UNITED STATES PATENT AND TRADEMARK OFFICE

APPLICATION NO.	FILING DATE	FIRST NAMED INVENTOR	ATTORNEY DOCKET NO.	CONFIRMATION NO.
10/645,484	08/22/2003	Hitoshi Nishimura	500.37529CC3	8733

Office Action Summary

DETAILED ACTION

Fig. 11

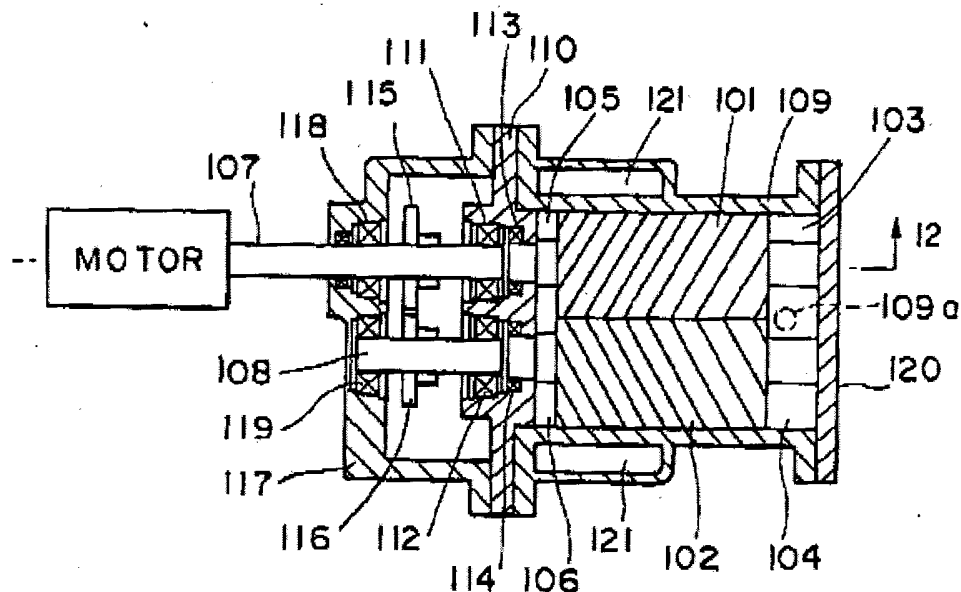
3. Claim 1 is rejected under 35 U.S.C. 102(b) as being anticipated by **Ozaki et al. (U.S. 5,674,063)**.

Ozaki teaches a screw compressor comprising: a compressor main body having a male rotor 101 and a female rotor 102 which are received in a casing a meshed with each other, first and second bearings 113, 114 for supporting the male rotor and the female rotor and a high speed motor driven by a high frequency inverter 202, said high speed motor having a motor shaft 107 in which the motor rotor is formed, a third bearing 118 for rotating and supporting the motor shaft, said first, second and third bearings being made the same with respect to each other. See particularly **Figure 11**, column 6 lines 6-8 of Ozaki.

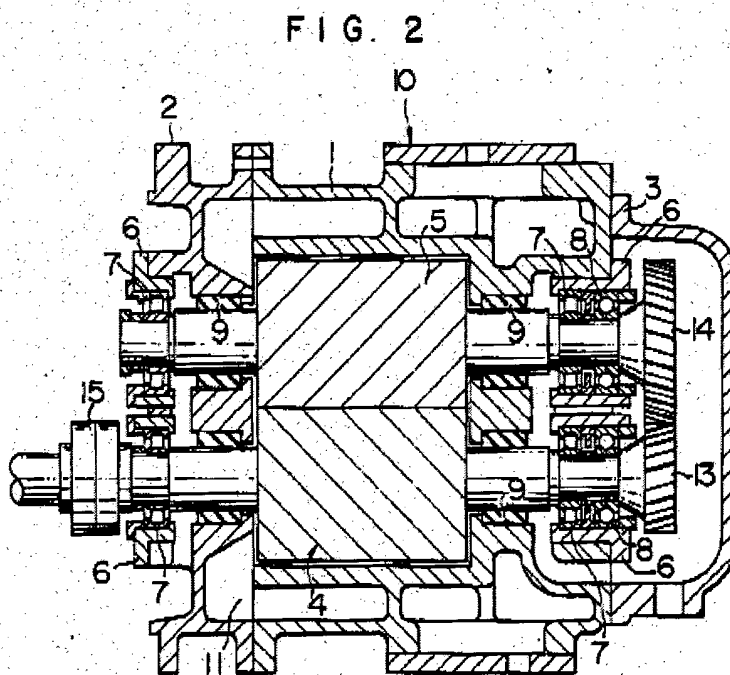
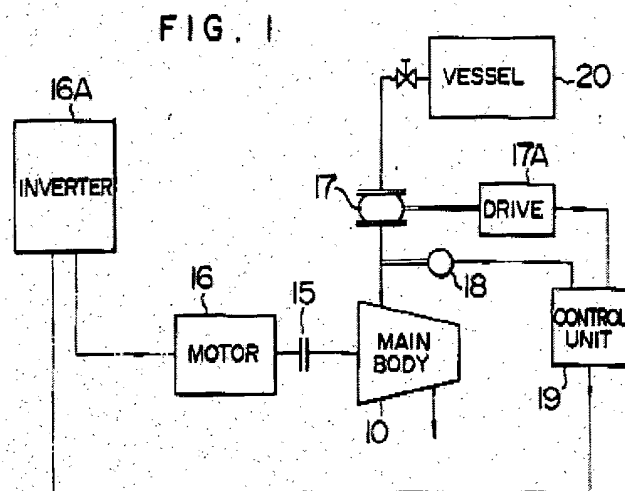
4. Claim 1 is rejected under 35 U.S.C. 102(b) as being anticipated by **Uchida et al. (U.S. 4,664,601)**.

Uchida teaches a screw compressor comprising: a compressor main body having a male rotor 4 and a female rotor 5 which are received in a casing a meshed with each other, first and

second bearings 8 for supporting the male rotor and the female rotor and a high speed motor 16 driven by a high frequency inverter 16A, said high speed motor having a motor shaft in which the motor rotor is formed, a third bearing 7 for rotating and supporting the motor shaft, said first, second and third bearings being made the same with respect to each other. See particularly **Figures 1, 2**, column 3 lines 64-66 of Ozaki.
